SUNDRY NOTICES AND REPORTS ON WELLS

SUBMIT IN TRIPLICATE - Other instructions on reverse side.				7. If Unit or CA/Agreement, Name and/or No.			
1. Type of Well ☐ Oil Well ☑ Gas Well ☐ Other				8. Well Name and No. HACKBERRY 33 FEDERAL COM 1

2. Name of Operator Contact: BRIAN MAIORINO COG OPERATING LLC E-Mail: bmaiorino@concho.com			9. API Well No. 30-015-34937				
3a. Address ONE CONCHO CENTER 600 W. ILLINOIS AVE MIDLAND, TX 79701 3b. Phone No. (include area code) Ph: 432-221-0467)	10. Field and Pool, or Exploratory HAPPY VALLEY;STRAWN

^{*}Please see attached current and proposed wellbore diagrams

Proposed Wellbore

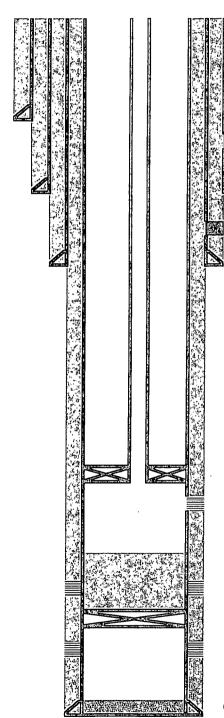
- 1. Operator shall tag CIBP at approximately 11,080'. Tag CIBP/PBTD and record.
- 2. Operator shall cement as proposed. Tag at 10,750' or shallower. <u>Must be witnessed by BLM.</u>

- 3. Must conduct a casing integrity test before perforating and fracturing. Submit results to BLM. The CIT is to be performed on the production casing to max treating pressure. Notify BLM if test fails.
